Subject: Former Mobil Station 04FGN, 14994 East 14<sup>th</sup> Street, San Leandro, California  
Fuel Leak Investigation Site No. RO0000422

Subject: Work Plan Addendum  
Former Mobil Station 04FGN, 14994 East 14<sup>th</sup> Street, San Leandro, California  
Fuel Leak Investigation Site No. RO0000422

ETIC Engineering, Inc. (ETIC) has prepared this Work Plan Addendum for ExxonMobil Environmental Services Company on behalf of ExxonMobil Oil Corporation for former Mobil Station 04FGN, 14994 East 14<sup>th</sup> Street, San Leandro, California. This Work Plan Addendum was prepared in response to a request by the Alameda County Health Care Services Agency (ACHCSA) dated 20 April 2009 (Appendix A).

SITE MAP SHOWING PROPOSED SOIL VAPOR MONITORING WELLS  
 FORMER MOBIL STATION 04FGN  
 14994 EAST 14th STREET  
 SAN LEANDRO, CALIFORNIA

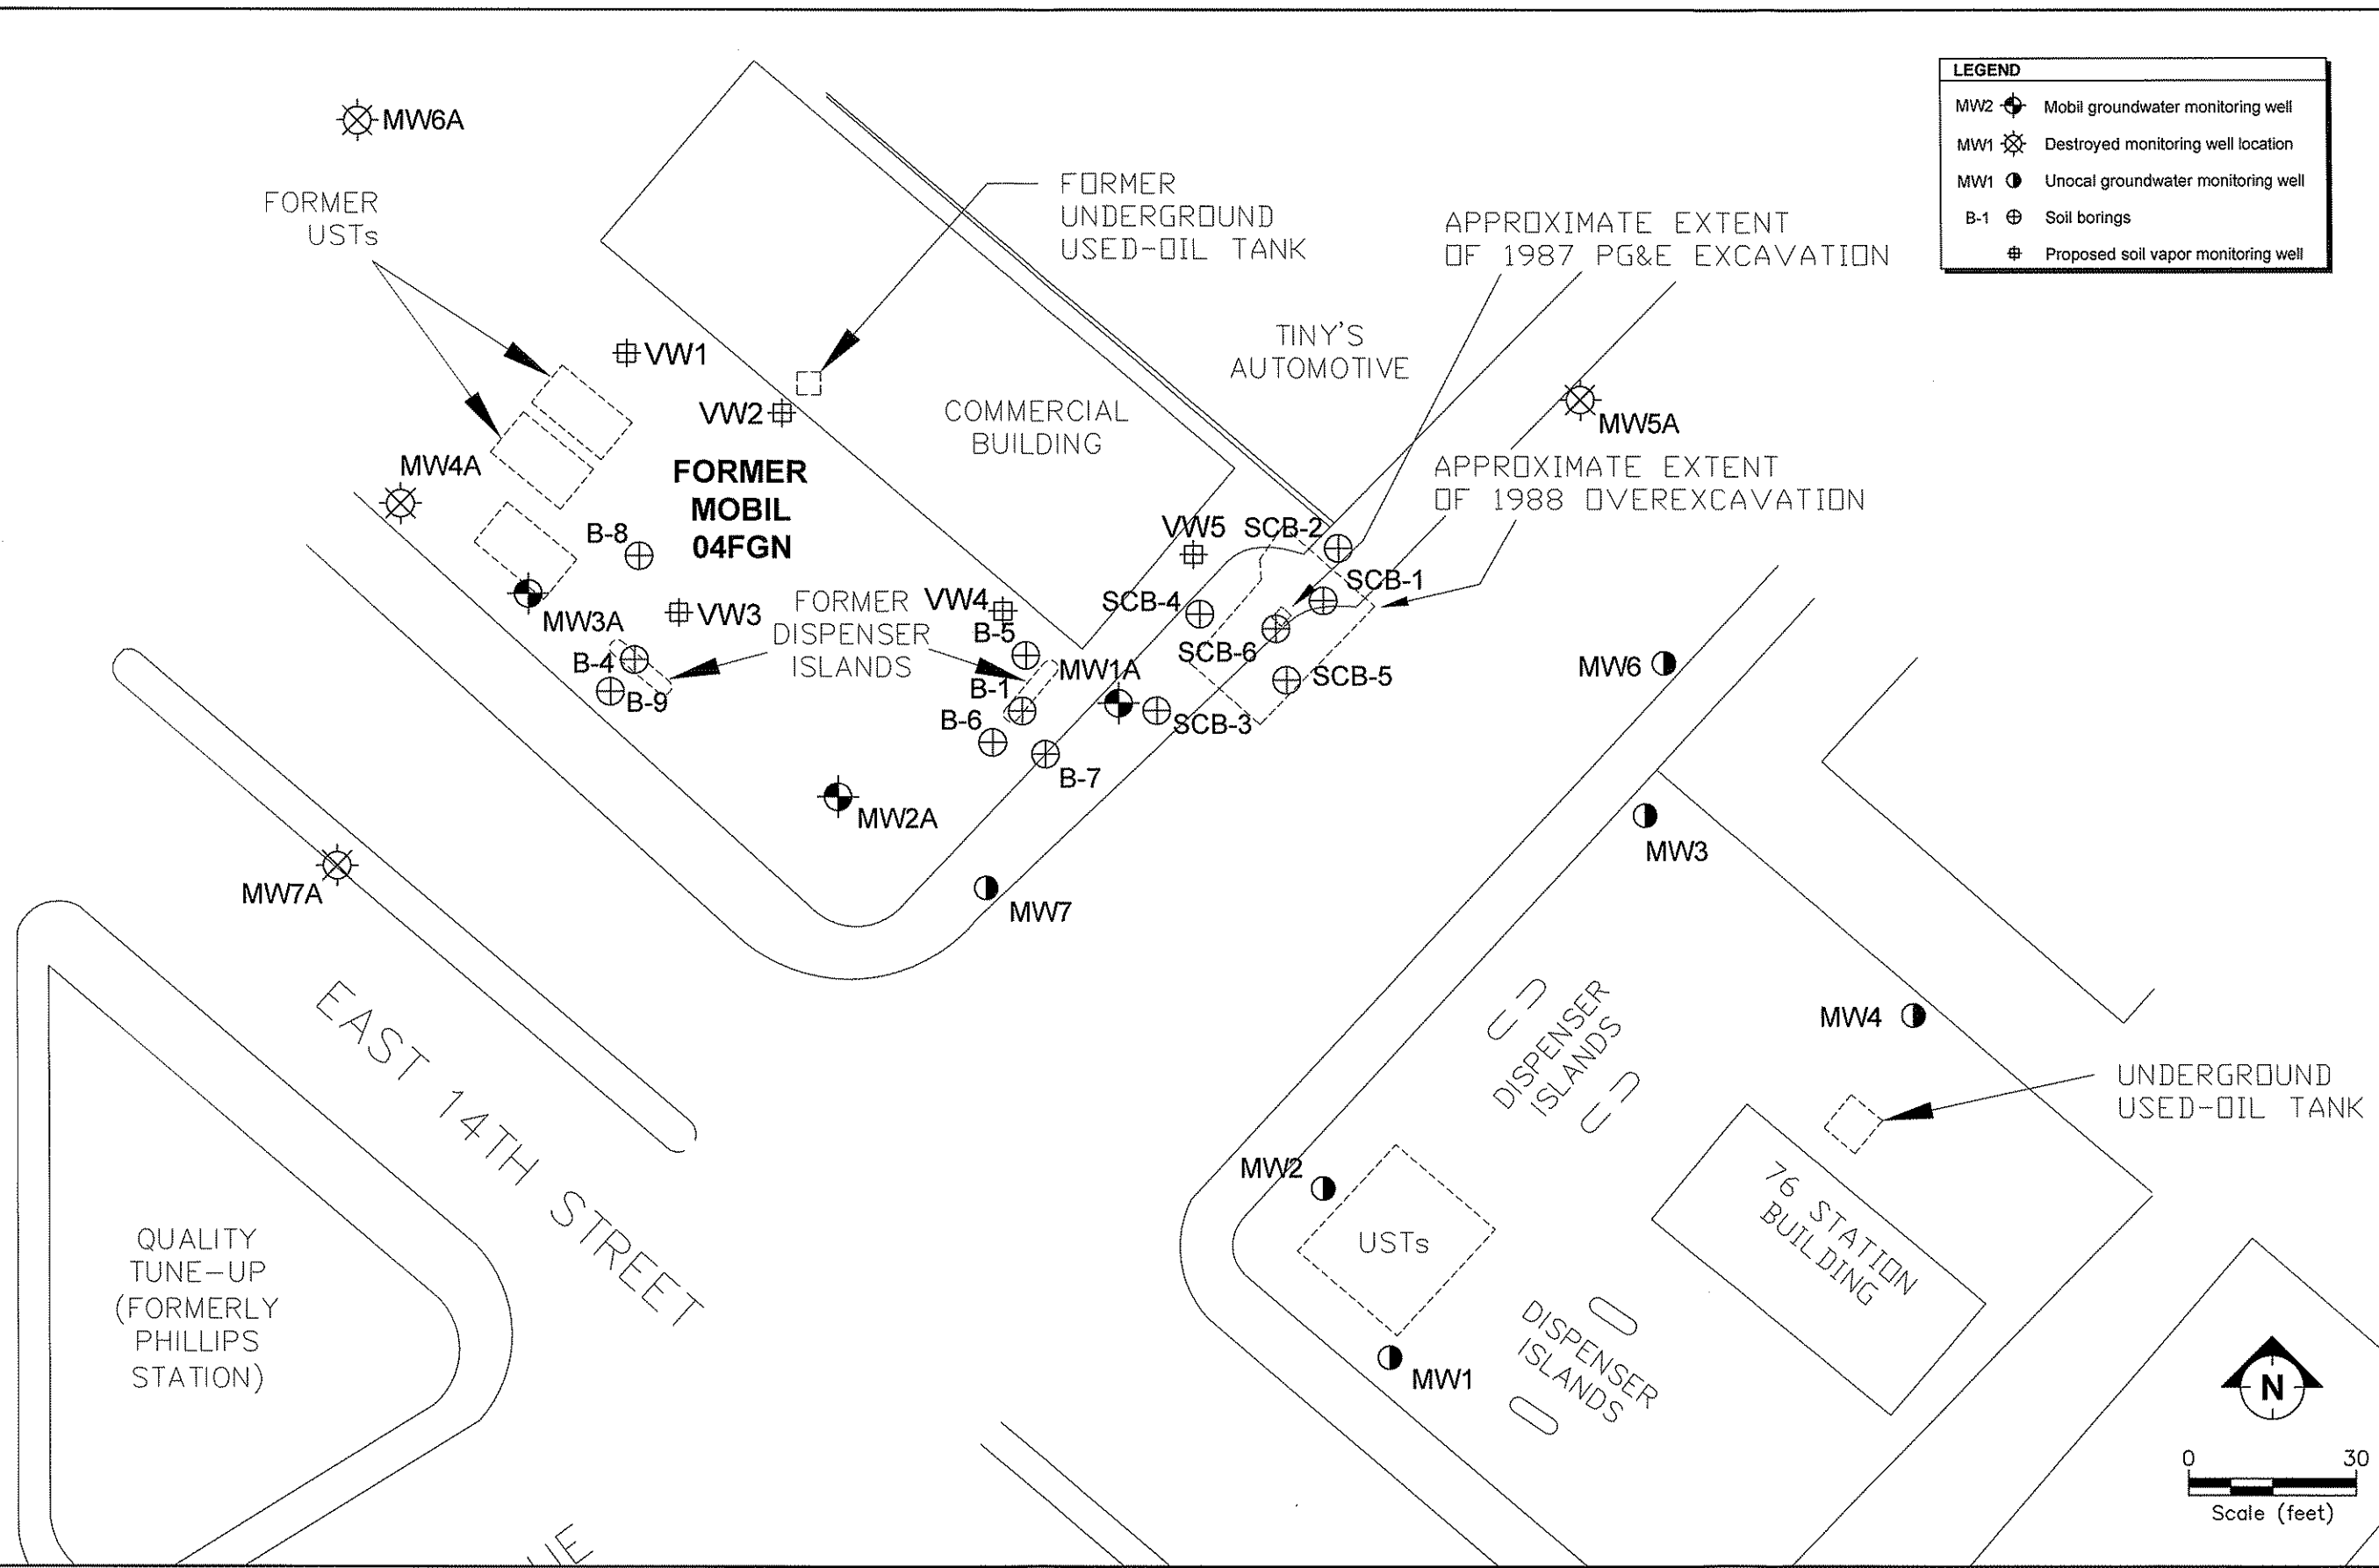
2. **Waste-Oil Tank Sampling.** ACEH's August 25, 2008, letter, we requested further information on the waste-oil tank removal. After a search of San Leandro files, ETIC discovered that only one soil sample was collected from the waste-oil tank. This sample was only analyzed for volatile hydrocarbons and extractable hydrocarbons. Both samples were below the detection limits. However, guidelines for waste-oil tank sampling include many other compounds, including metals. While advancing the proposed soil borings for soil vapor well installation adjacent to the waste-oil tank, please include volatile organic compounds (VOCs) including chlorinated hydrocarbons by EPA Method 8260 and metals (Cd, Cr, Pb, Ni, and Zn) by ICAP or AA for soil samples and include chlorinated VOCs (EPA Method 8260 or TO-15) analysis for the vapor samples.

Well VW2 will be installed close to the location of the former used-oil tank (Figure 1). The compounds listed above will be added to the compounds proposed in the work plan for the soil and soil vapor samples collected from VW2. In addition, a soil sample collected during the installation of well VW4 will be analyzed for metals (Cd, Cr, Pb, Ni, and Zn) by ICAP or AA in order to gauge the relative background concentrations of those metals for comparison to the analysis of metals for the soil sample from VW2.

WELL COMPLETION DIAGRAM FOR  
 PROPOSED SOIL VAPOR MONITORING WELLS  
 FORMER MOBIL STATION 04FGN  
 14994 EAST 14TH STREET, SAN LEANDRO, CALIFORNIA

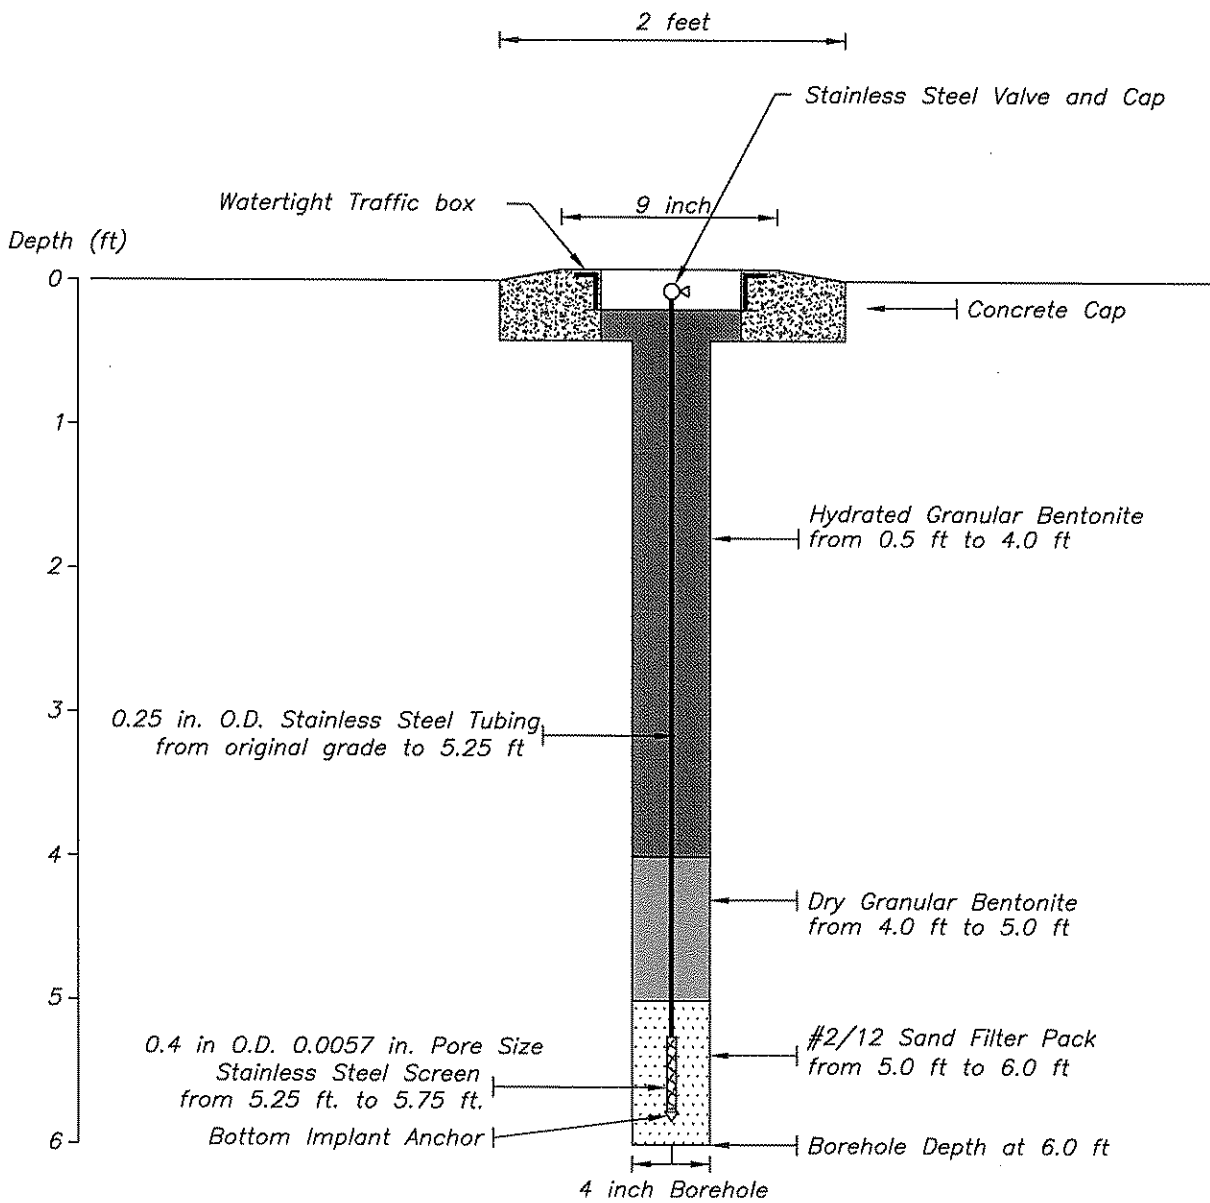
- As per the DTSC *Advisory – Active Soil Gas Investigations* (January 28, 2003), use dry granular bentonite immediately above the sand pack to prevent the hydrated bentonite grout from infiltrating rather than bentonite chips as shown on your diagram and hydrated bentonite above the dry granular bentonite rather than neat cement grout.

1. **As per the DTSC Advisory – Active Soil Gas Investigation (28 January 2003), use dry granular bentonite immediately above the sand pack to prevent the hydrated bentonite grout from infiltrating rather than bentonite chips as shown on your diagram and hydrated bentonite above the dry granular bentonite rather than neat cement grout.** The soil vapor monitoring wells will be constructed with dry granular bentonite immediately above the sand pack and hydrated bentonite will be placed above the dry granular bentonite. Refer to Figure 2 for a revised well construction diagram and Appendix B for construction details.
